PROJECT **123A90 - HOLLANDSE KUST NOORD WIND PARK**
BLPH Project

MECHANICAL COMPLETION DOSSIER (ONSHORE)

Junction Box 950-JE-02102 and Multi-core cable (FGS System)

PUNCH ITEM ENTRY / CLEARANCE FORM

C30002534

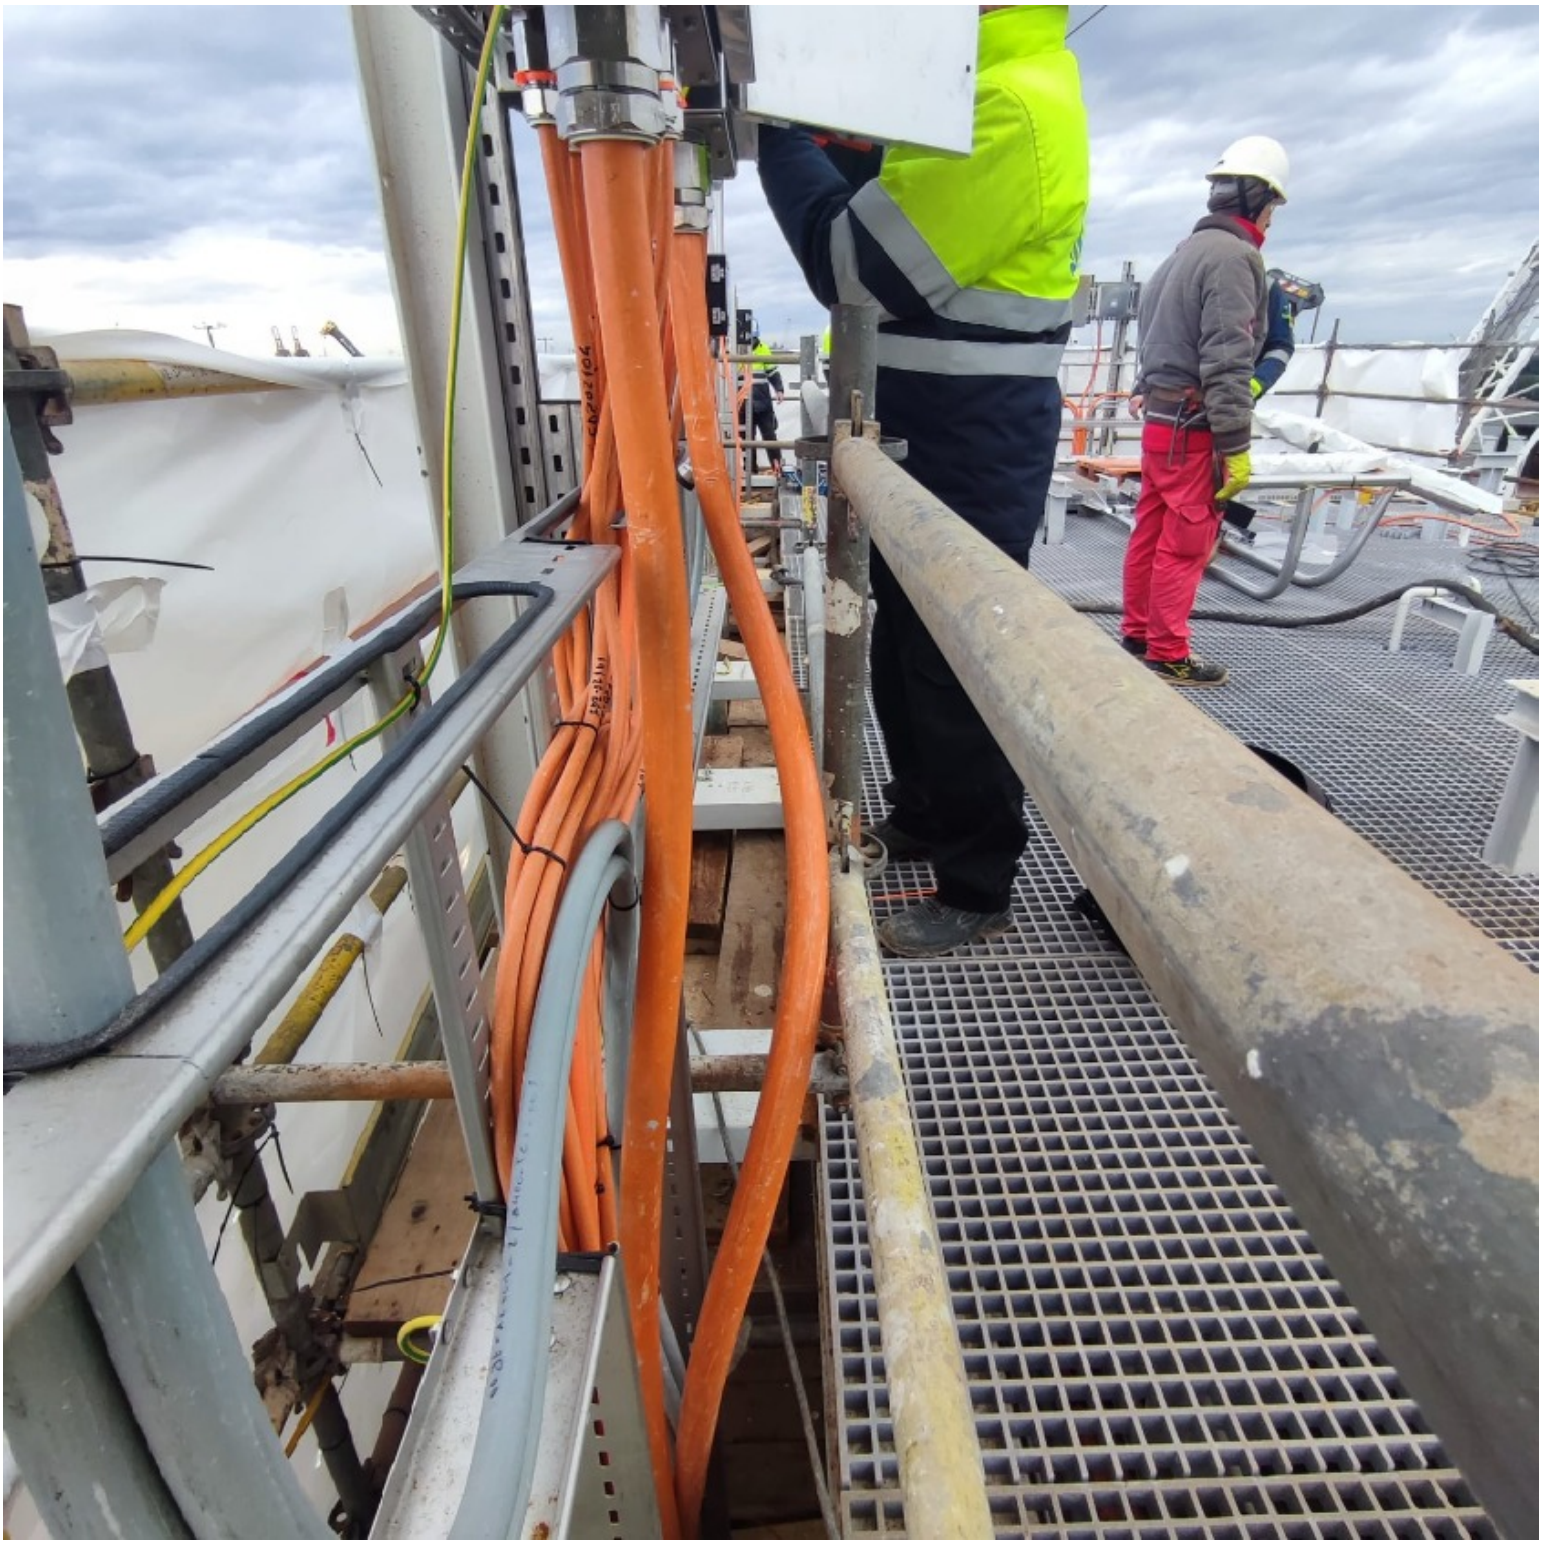
Cable is outside the cabletray.

DONE
